Project:	EPS
Part Number:	80000258
Assembly Name:	LH7A404-11
Schematics	ECR

Title	LH7A404-11 Card Engine	Rev	201
Size	Custom	Number	80000258
Design Create Date	Friday, October 18, 2002	Project	LH7A404-11
		Sheet	2 Of 12

## 12 - ECO LIST

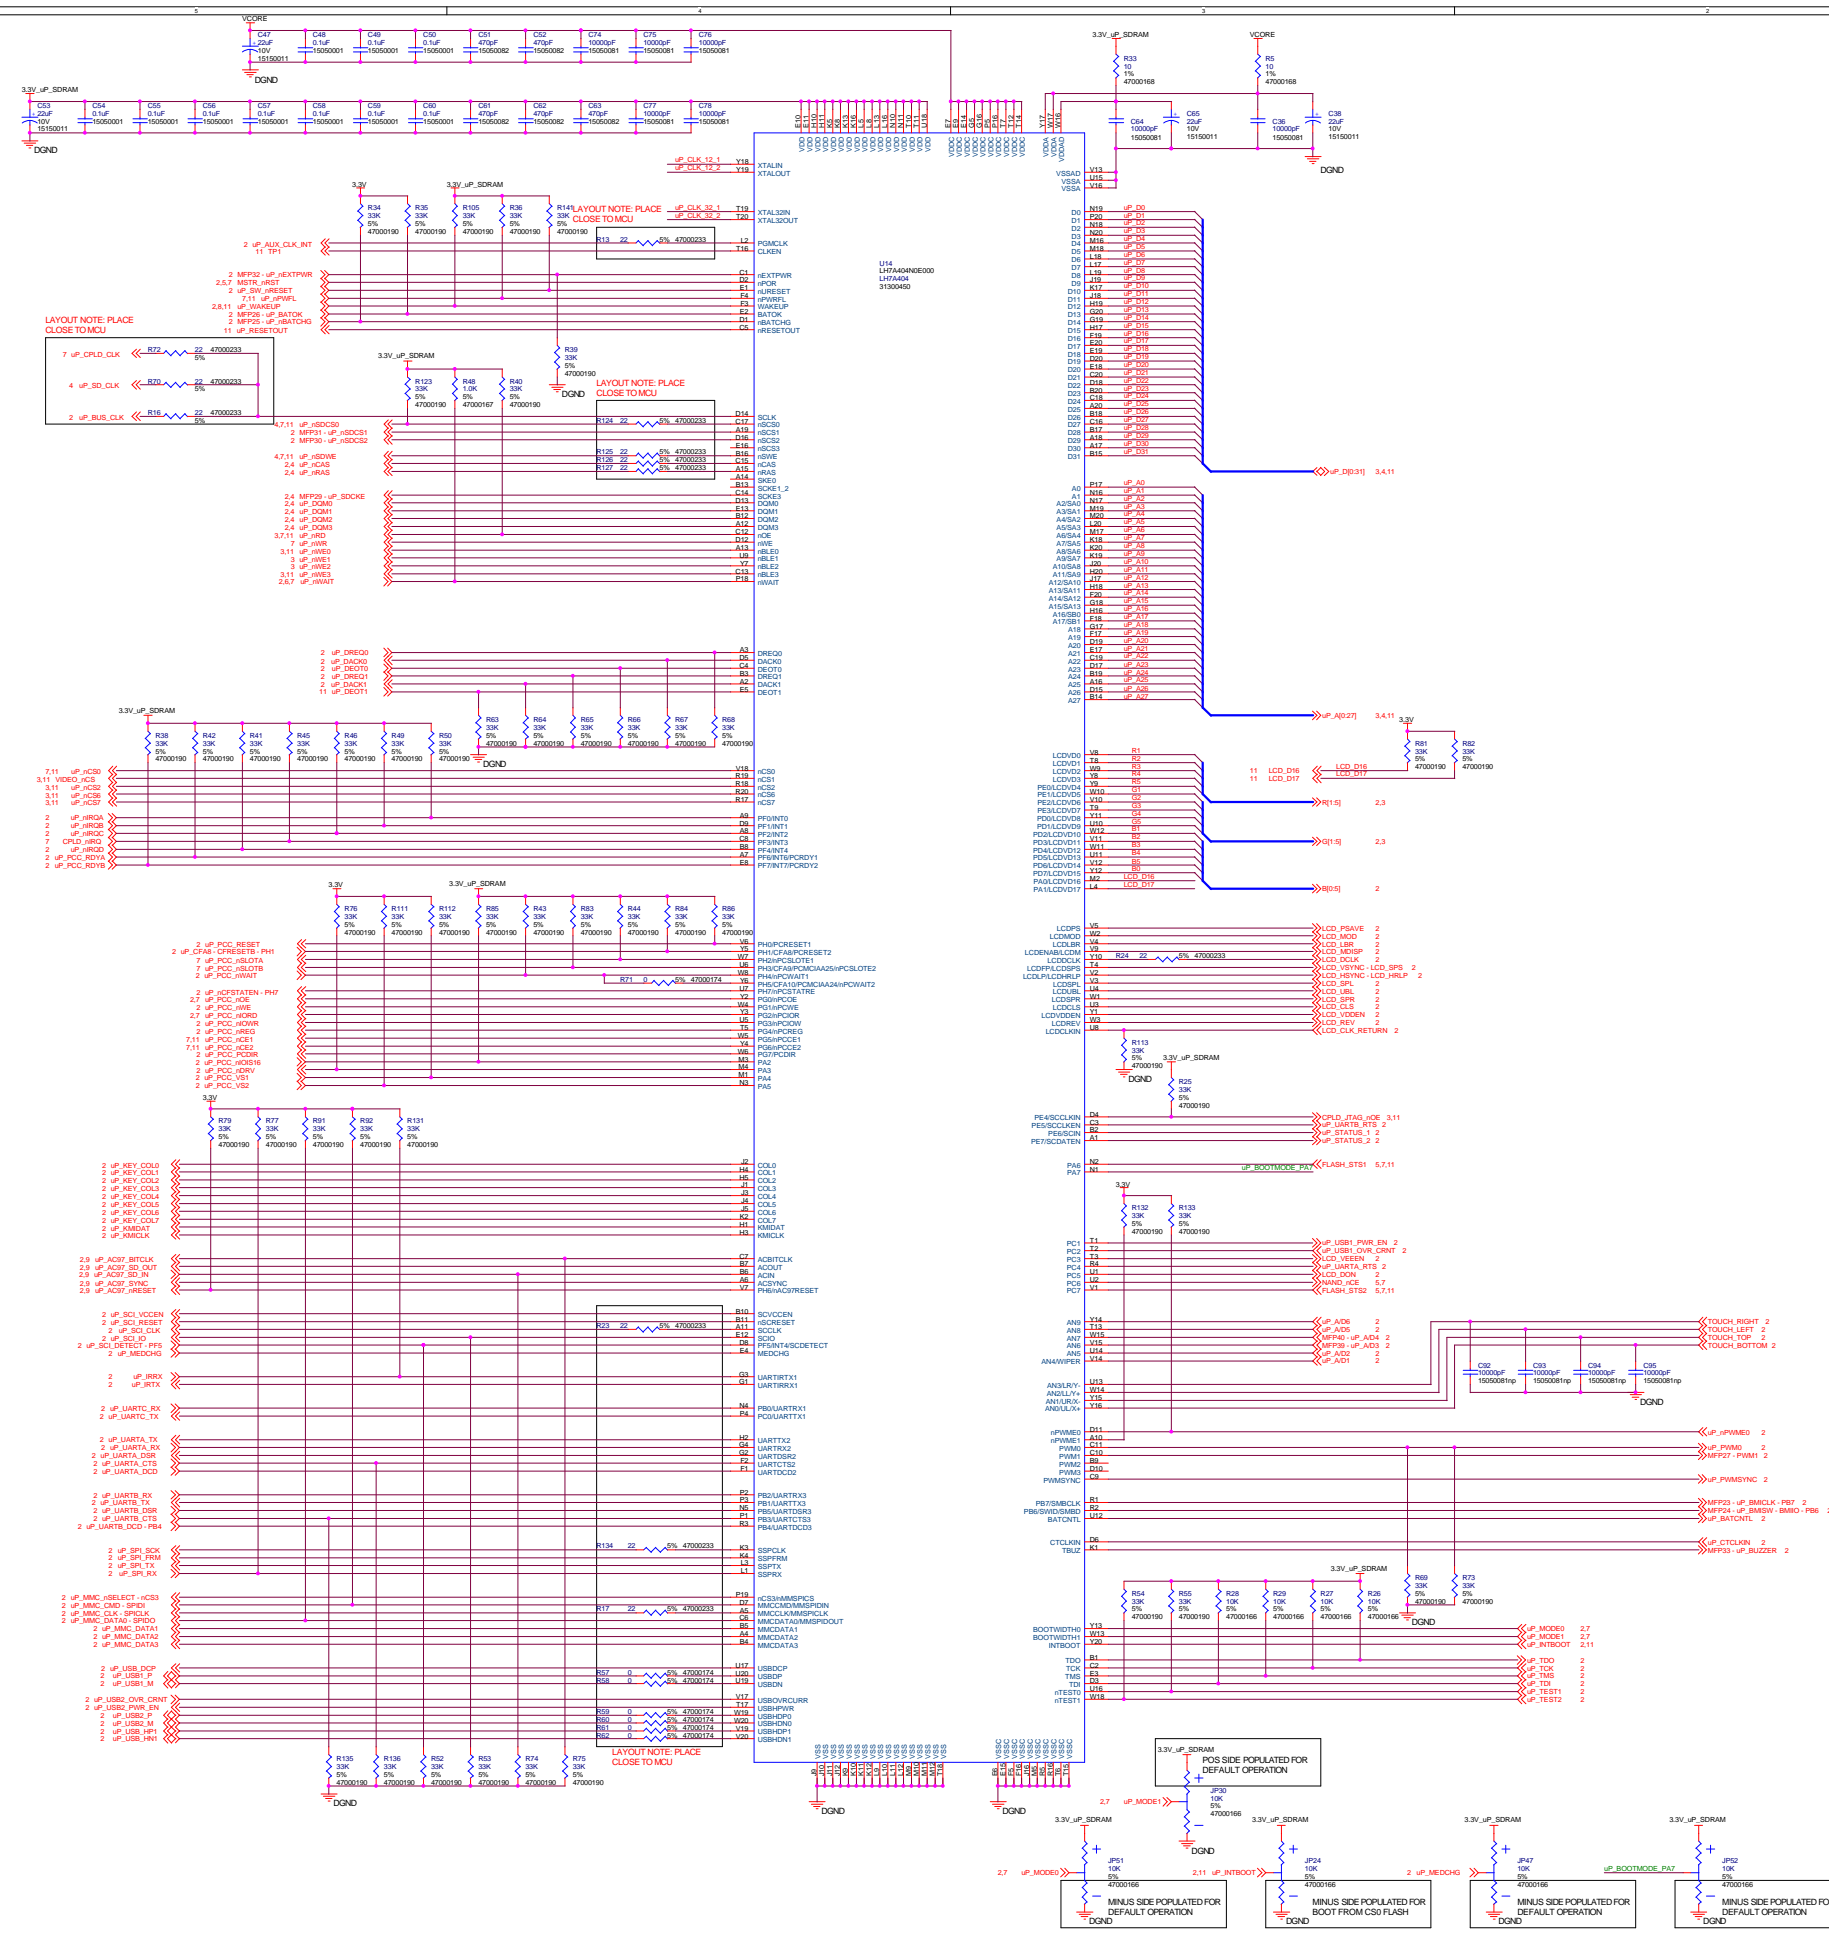
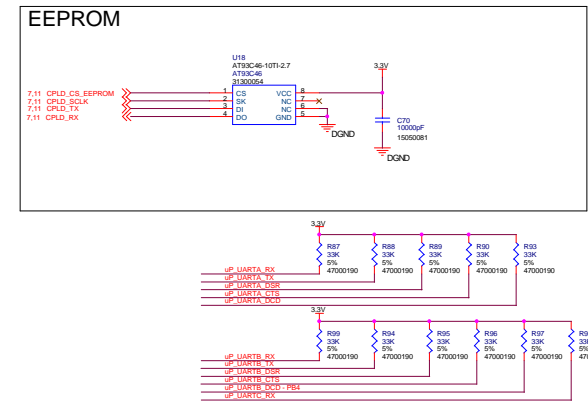
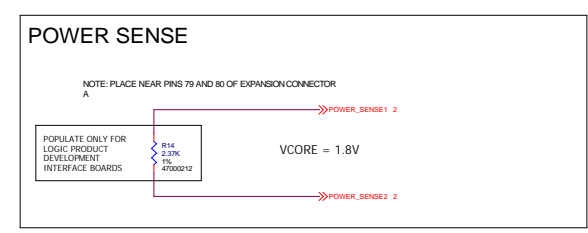
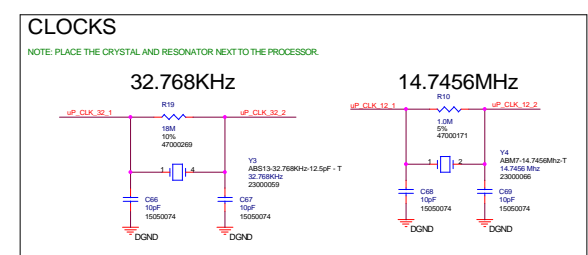
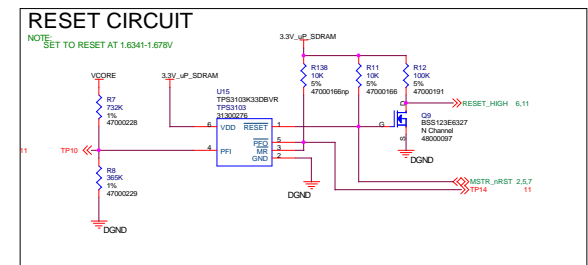
- REVISION 3 -> 101
- MOVED FROM PBGA TO CPGA PACKAGE
  - REMOVED DOUBLE PULLUP ON MSTR\_RESET (R37)
  - ADDED FILTER CAPS TO TOUCH LINES AS NO POPPS
  - REMOVED MOVED NETS UP\_PCC\_BV01 AND UP\_PCC\_BV02 TO THE FPGA AND R114 AND R115

- RENAMED NET UP\_SCL\_MEDCHG TO UP\_MEDCHG
  - MOVED NET FLASH\_ST1 FROM PCB TO PA6 TO ENABLE NAND FLASH INTERFACE, ADDED SIGNAL\_NAND\_NCE TO PCB
  - REMOVED NET UP\_PER AND REPLACED IT WITH UP\_UARTB\_RTS

- ADDED 22 OHM SERIES RESISTORS ON THE SDRAM CONTROL SIGNALS UP\_HSDO0, UP\_HRAS, UP\_ICAS, UP\_HSDWE
  - REMOVED PULLUPS/PULLDOWNS ON UP\_SPL\_FRM AND UP\_SPL\_TX TO MATCH A00; ADDED PULLDOWNS ON UP\_UARTA\_CTS AND UP\_UARTB\_CTS

- ADDED PULLUP ON RESET\_CKT ON F04R BECAUSE PFO IS AN OPEN DRAIN OUTPUT AND IS CONNECTED TO MR. IS NO POP FOR NOW BECAUSE IT IS CURRENTLY WORKING
  - ADDED NEW NET FROM CPLD: UP\_PVWL

- REVISION 101 -> 201
- ADDED 33K PULLUP TO NET UP\_HSW\_RESET
  - CHANGED NET NAME OF CPLD\_VCS\_EEPROM TO CPLD\_CS\_EEPROM BECAUSE IT IS ACTIVE HIGH
- REVISION 2 -> 3

- MOVED UP\_PCC\_IOIS16 TO PA2
  - TIED WAIT1 AND WAIT2 SIGNALS TOGETHER THROUGH R71
  - TIED VDDA3 TO 3.3V FOR TOUCH CIRCUITRY
  - CHANGED PULL UP R48 TO 10K OHM

- SWAPPED USB1\_USB2 AND USB DEVICE DATA AND CONTROL SIGNALS AROUND TO SUPPORT DEVICE AND HOST FUNCTION ON SDK APPLICATION BOARD
  - CHANGED UP\_HRDV, UP\_PAL, UP\_CFA6 - CFA25 - ICREF8 - PH13 TO UP\_S0UT1, UP\_HRV, UP\_S0UT2

- REMOVED UP\_PVWEN1, UP\_PVW1, UP\_PVW2, UP\_PVW3, UP\_S0KEL, UP\_S0K1, UP\_S0K2, UP\_HSDCS3 CIRCUITRY
  - SWAPPED MFP12 - UP\_EXT\_PWR AND UP\_BUZZER

# 11 - TEST POINTS

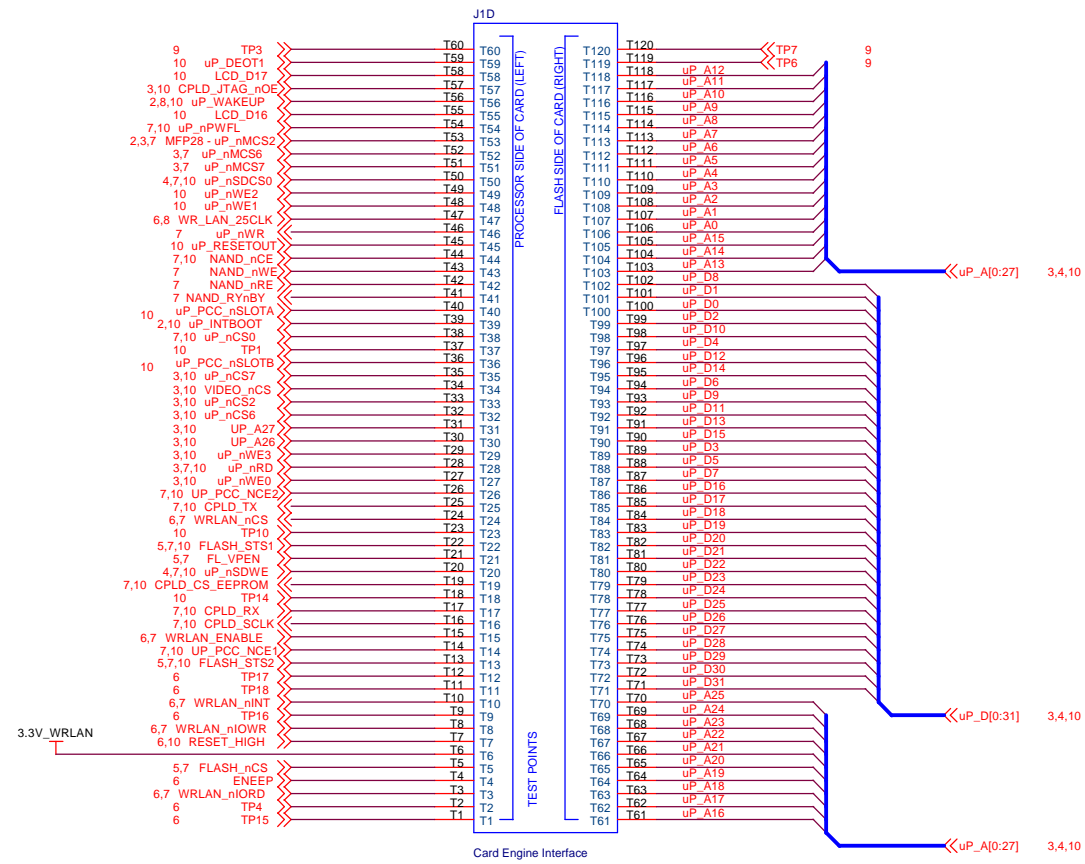
1) CHANGED NET NAME OF CPLD\_nCS\_EEPROM TO CPLD\_CS\_EEPROM BECAUSE IT IS ACTIVE HIGH

1) ADDED uP\_MCS6, uP\_MCS7, MFP28 - uP\_nMCS2 TO TESTPOINTS

1) REMOVED uP\_SDCKE

1) REMOVED TP11 AND TP12
